RE: Kum & Go 0198 – Site Plan Submittal #2

CUMMING, IOWA KUM & GO REVISED SITE PLAN AND PUBLIC IMPROVEMENTS

SITE PLAN DRAWINGS STORE #0198 I-35 & CUMMING AVENUE CUMMING, IA 50061

PUBLIC IMPROVEMENT DRAWINGS STORE #0198 I-35 & CUMMING AVENUE CUMMING, IA 50061

0198 - CUMMING, IOWA I-35 & CUMMING AVENUE AUTOTURN EXHIBIT - WB-67

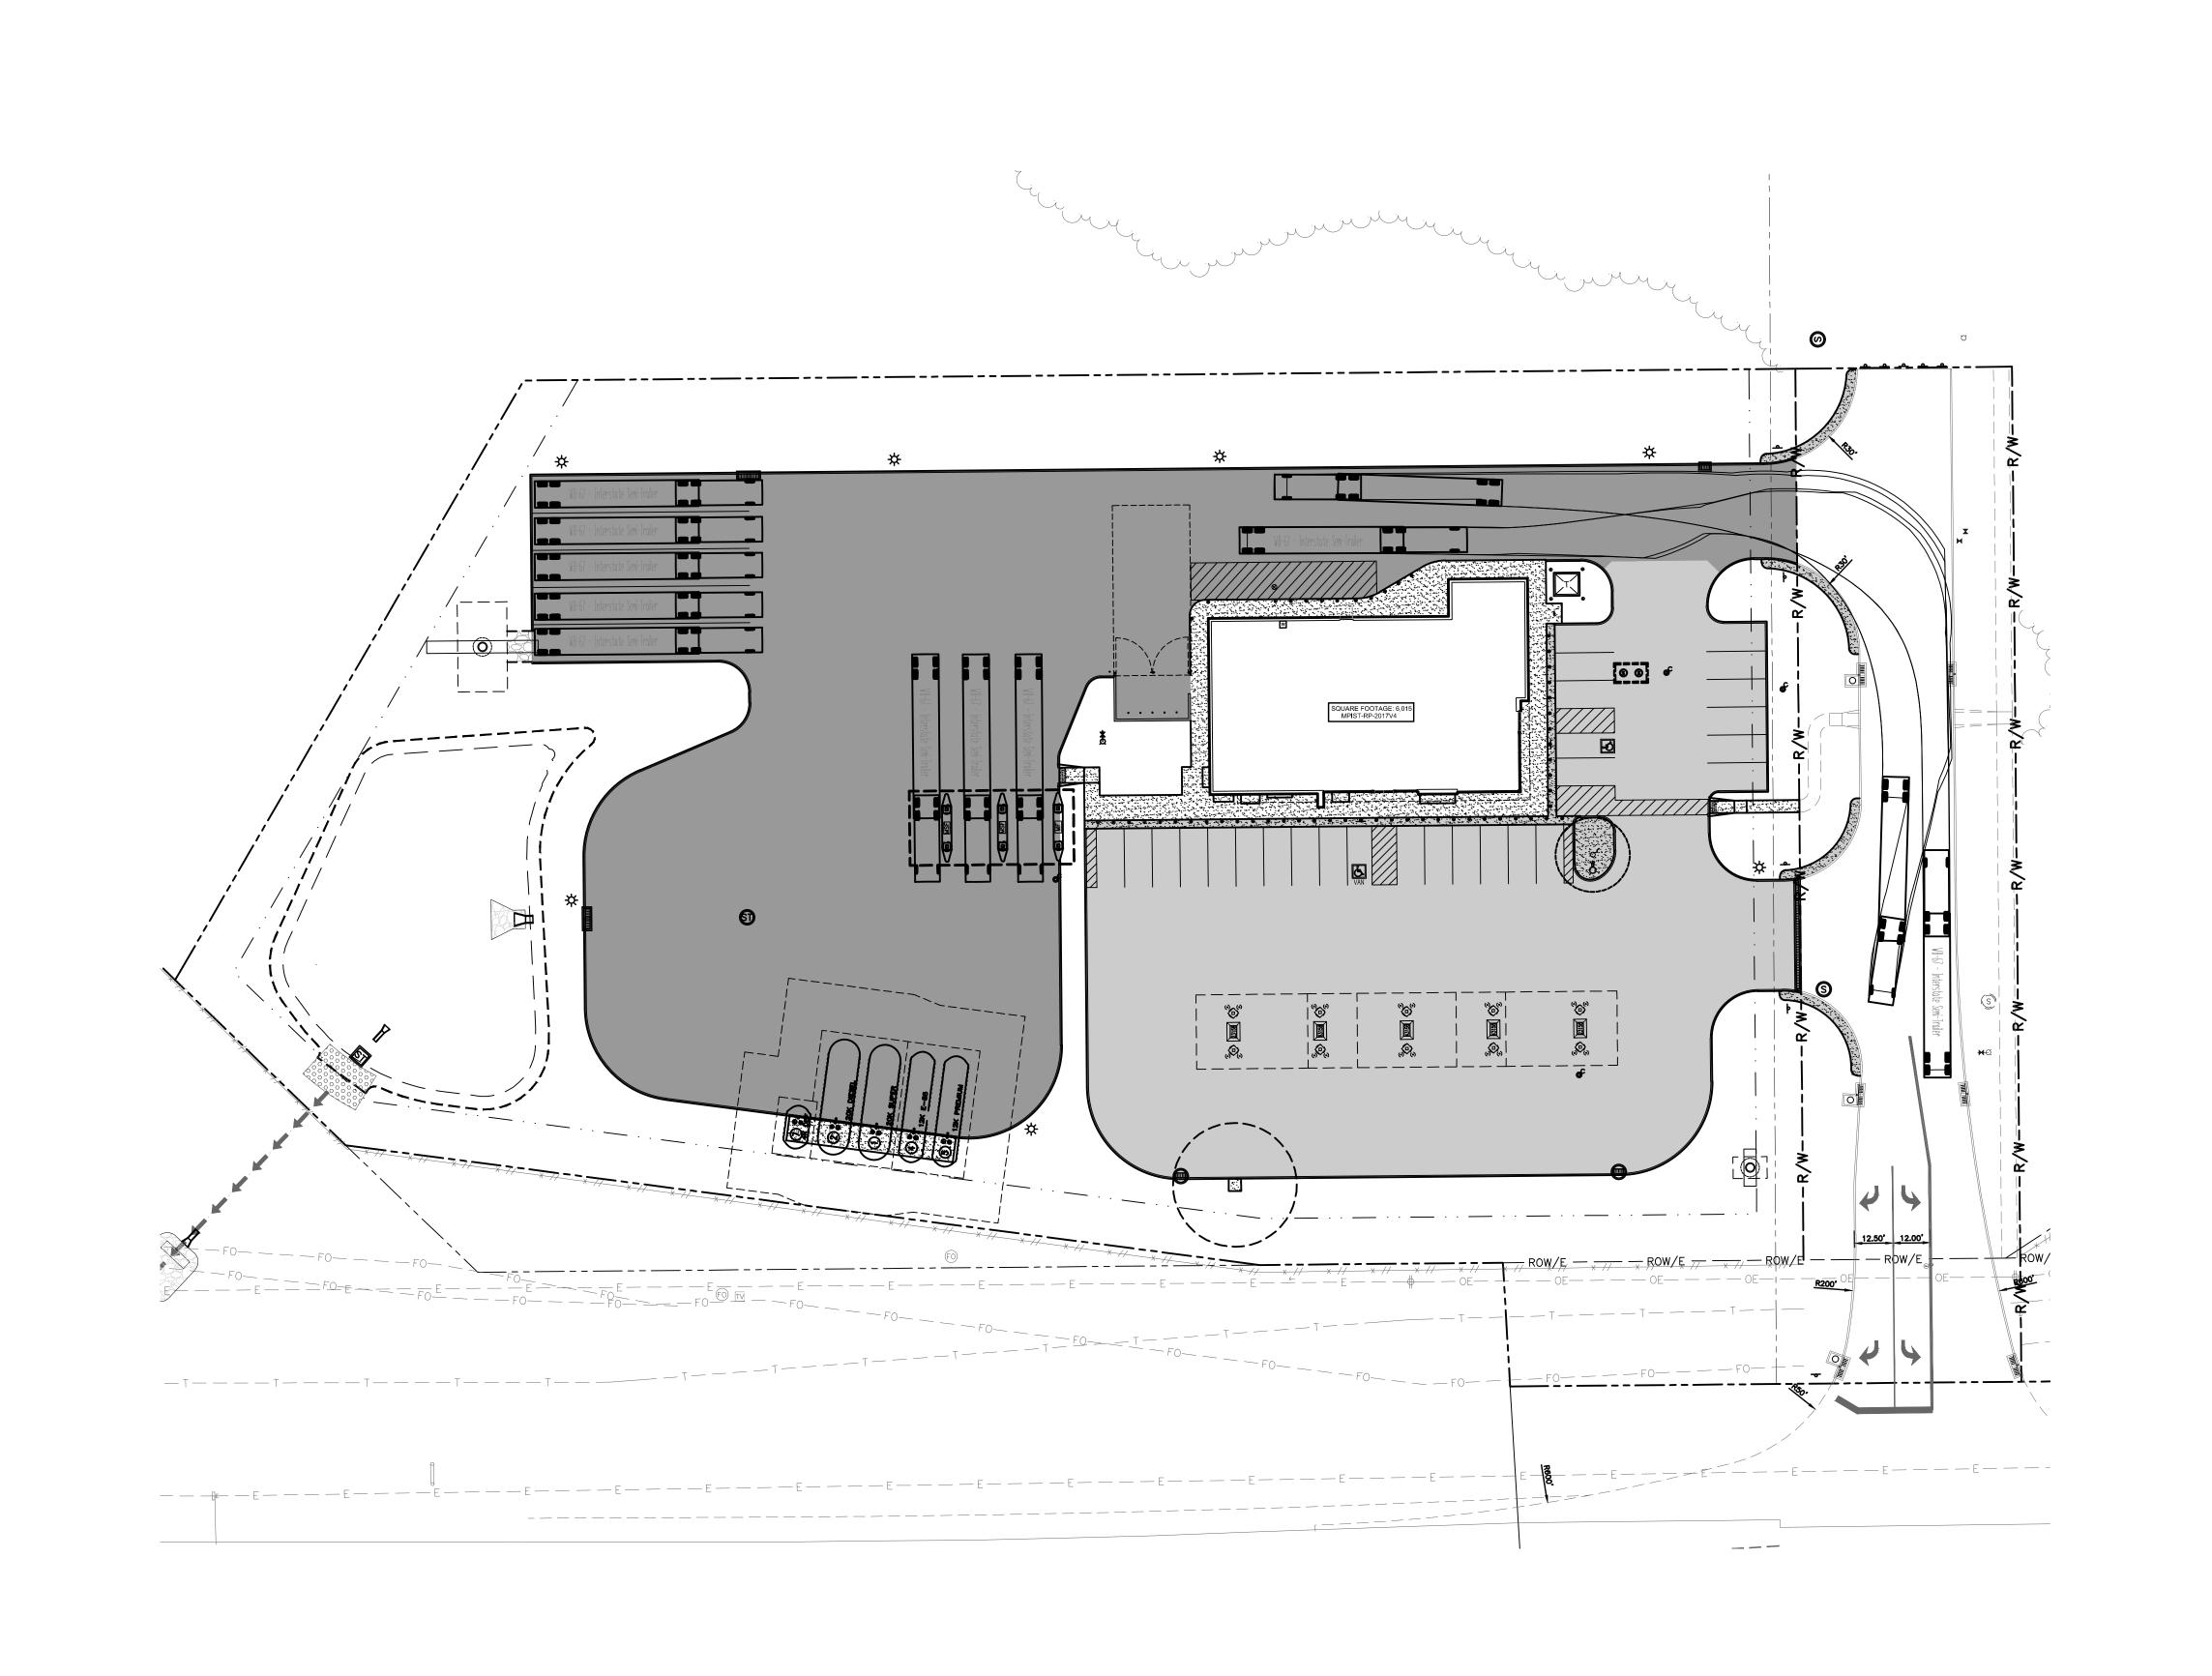
Sheets 1 - Autoturn Exhibit

1. In reviewing the turning radii of truck movements as shown that a continuous left turn lane should be considered to provide three lanes of traffic. This street will carry considerably more traffic when the Lot 2 is developed to the east, and the street is extended north to serve future commercial and residential development. The continuous left turn lane will keep the southbound truck movement within the left turn lane rather than into the northbound lane and will allow additional stacking for multiple trucks/vehicles.

SHEET NUMBER: **2 OF 10**

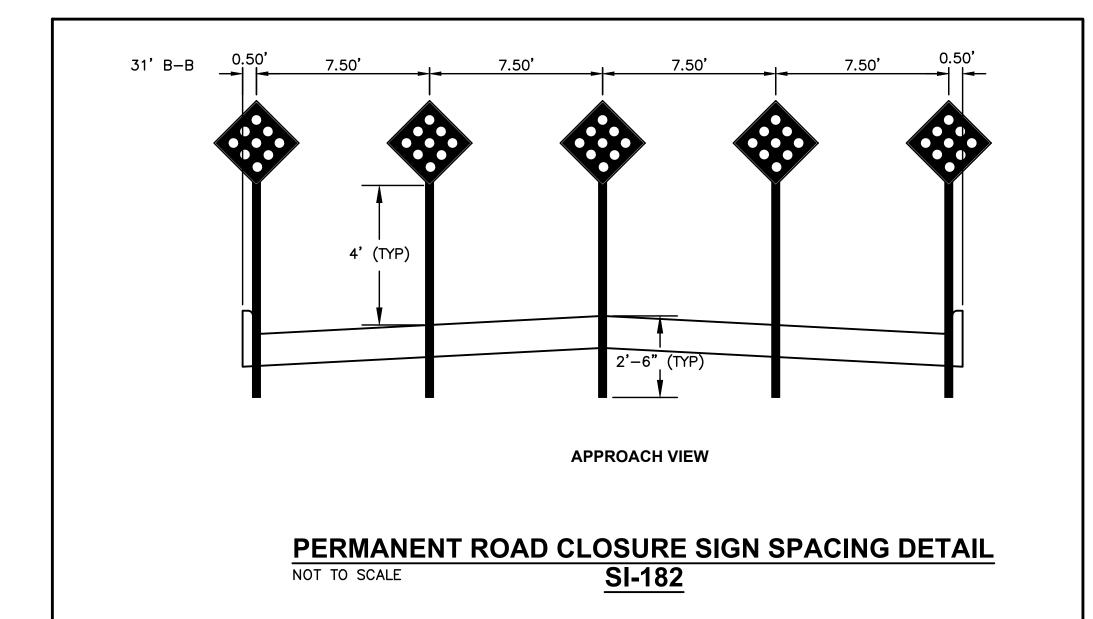
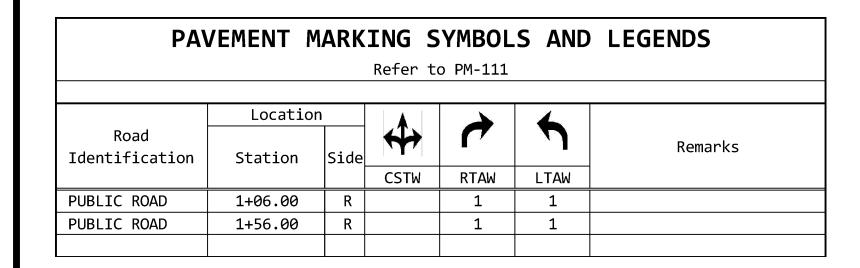
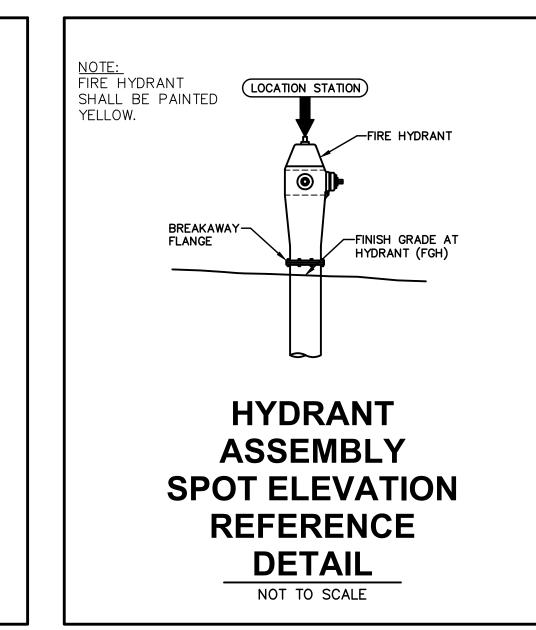
12. The Comprehensive Plan does not clearly address the functional classification of the street (Lot A). The preliminary plat appears to indicate that Lot A is to be a minor collector having 70 feet of right-of-way and 31 feet of pavement width. It appears 37 feet is provided for a left turn lane at the intersection with Cumming Avenue. This may need to be widened somewhat in the intersection area for truck turning movements. The County may have input on this in their review of the Cumming Avenue Improvements.

13. The public street serving the Kum & Go site should have pavement thickness of 8-inch PCC in lieu of 7-inch PCC. The 8-inch PCC will be consistent with the 8-inch PCC pavement provided on-site for the trucks and the commercial development anticipated to occur in the adjoining area.

- 1. As noted previously, it is suggested that a third continuous left turn lane be added a minimum 12 feet wide for a total three lane pavement width of 37 feet. The continuous left turn lane may be wider to 14 feet wide as suggested by the Manual on Uniform Traffic Control Devices (MUTCD).
- 2. Pavement thickness has been revised to 8 inches.

The turning radii footprint of trucks has been changed to a Three-Centered Compound Curve to accommodate better truck turning movements. A turning movement exhibit has been included with this submittal for your reference.

Pavement thickness has been changed to 8-inch thickness.

JOINTING PLAN

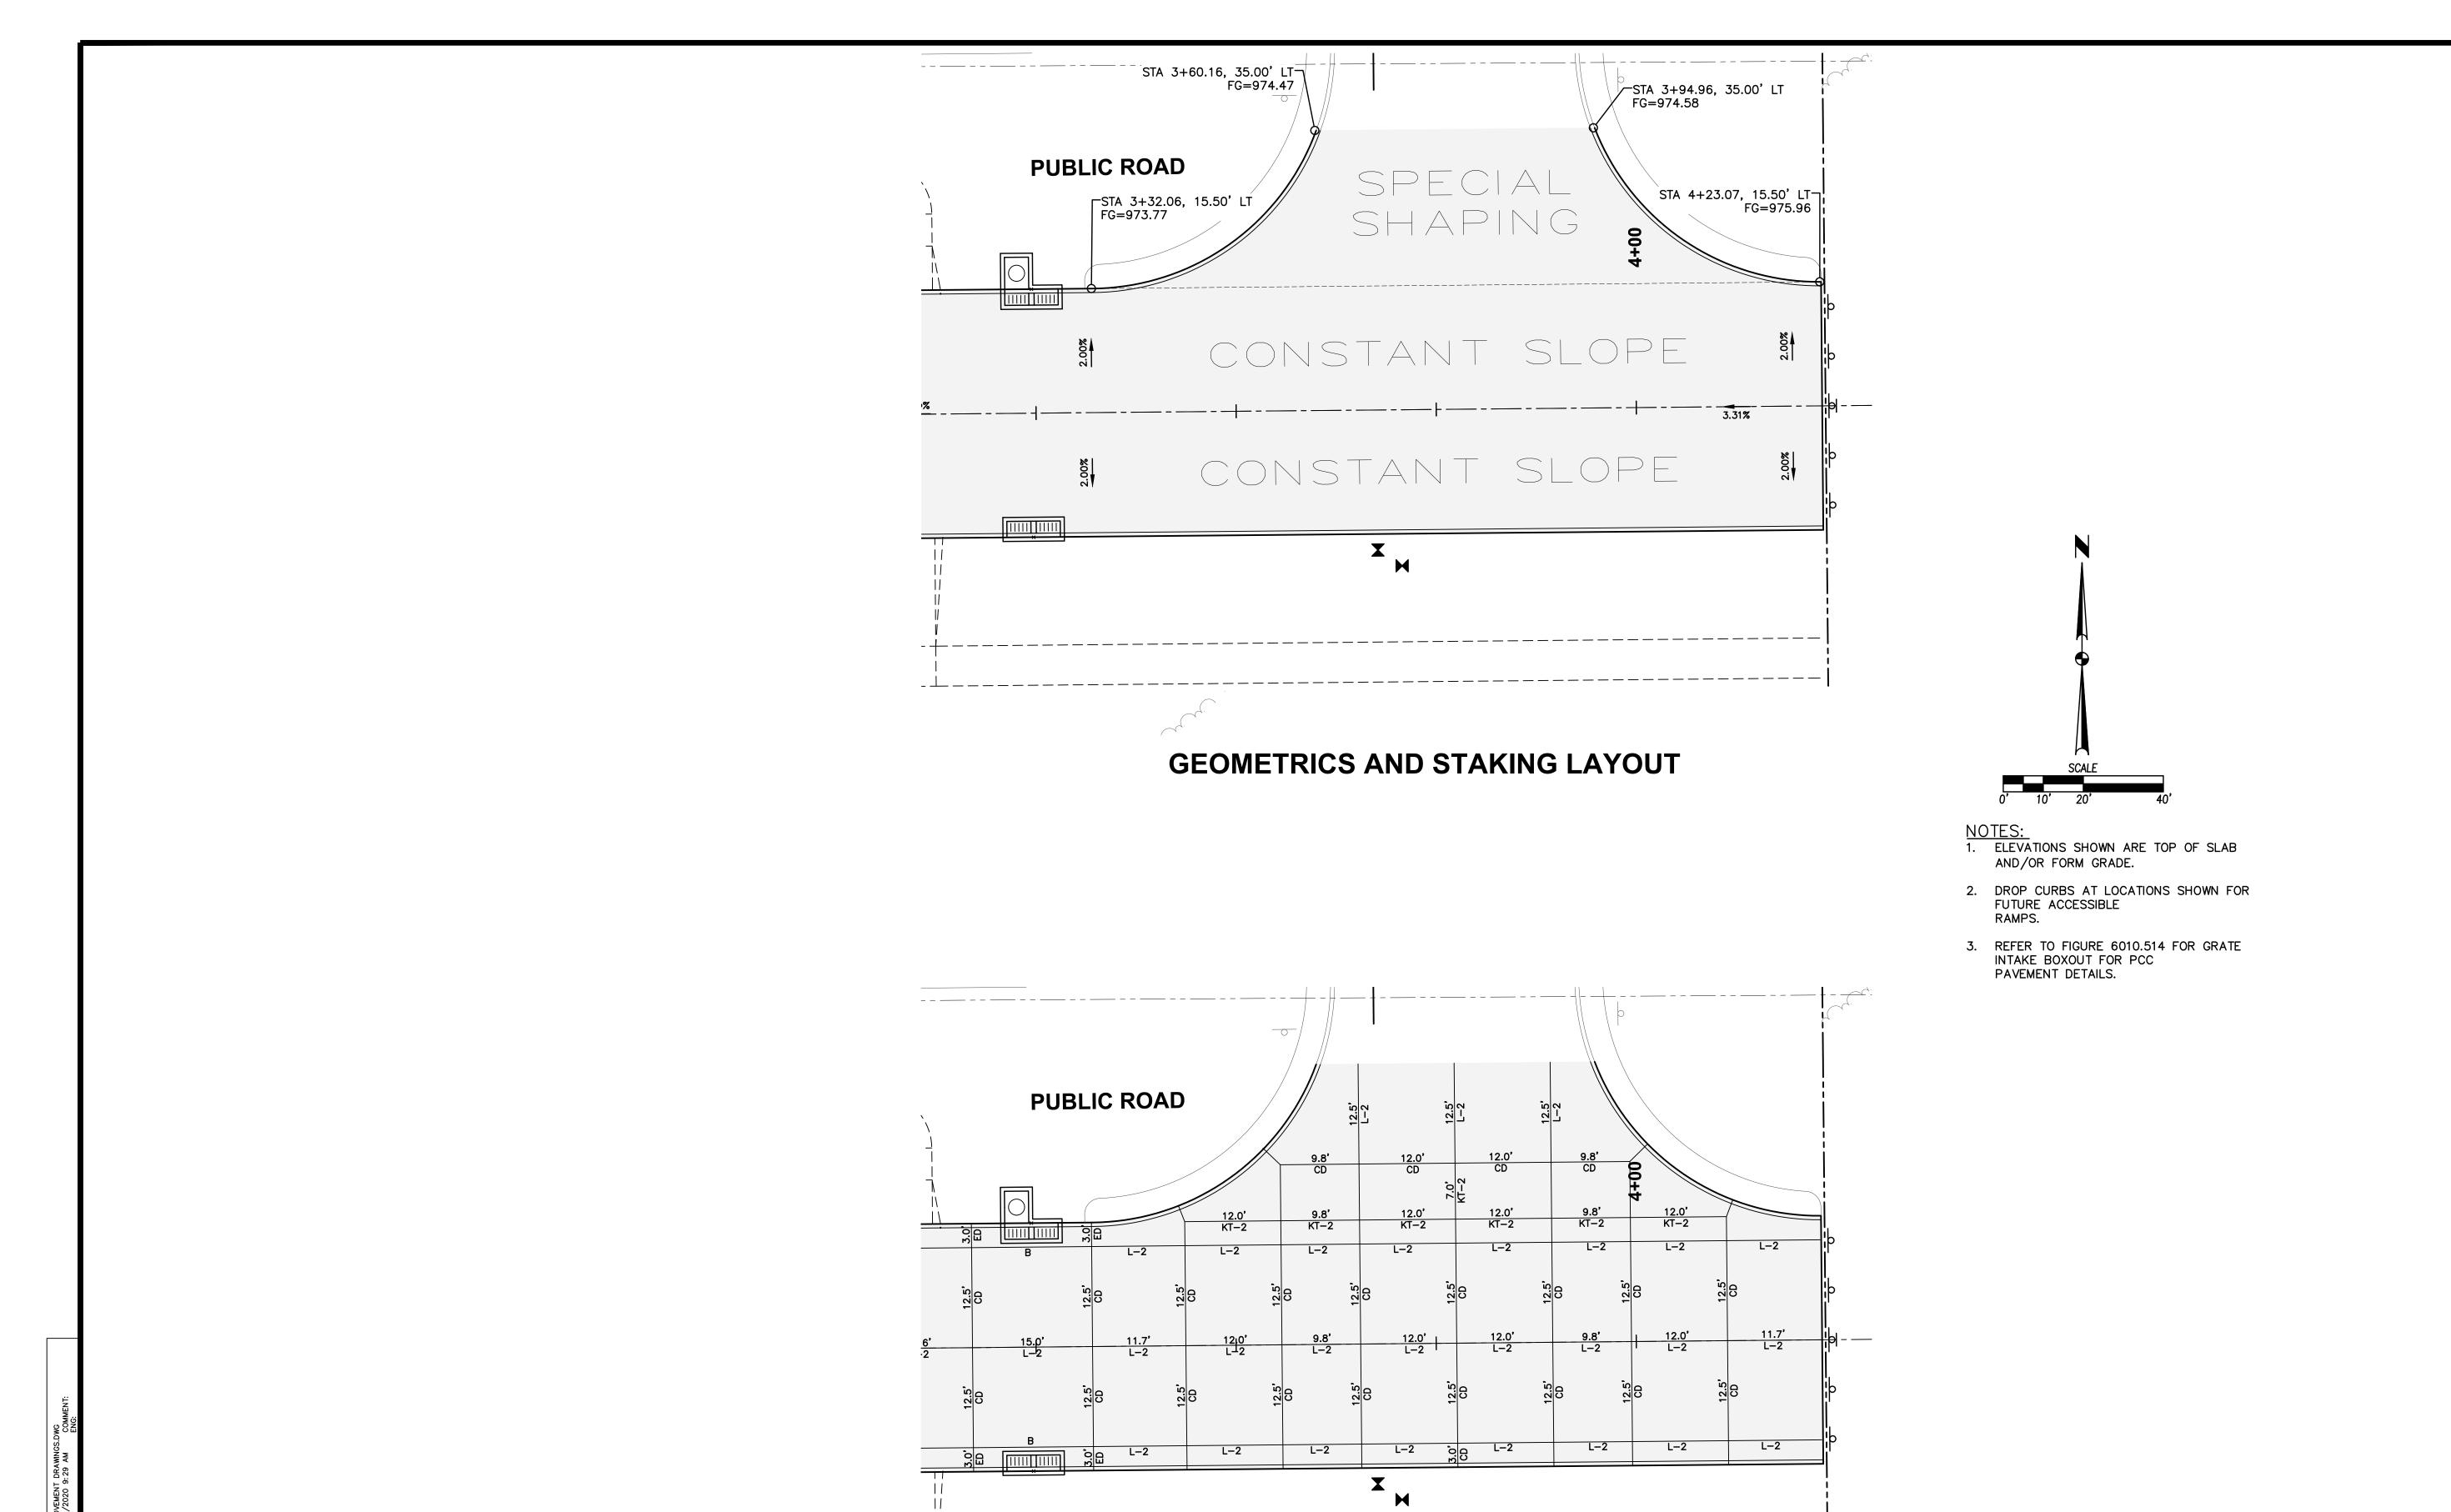
16. As noted previously, it is recommended the pavement of the public road should be 8-inch PCC, including KT-2 and L-2 joints. The CD joints as shown are appropriate for an 8-inch thick pavement.

1. The RT-2 and L-2 joints are shown for the 8-inch thick pavement.

Joint types have been updated per recommendations.
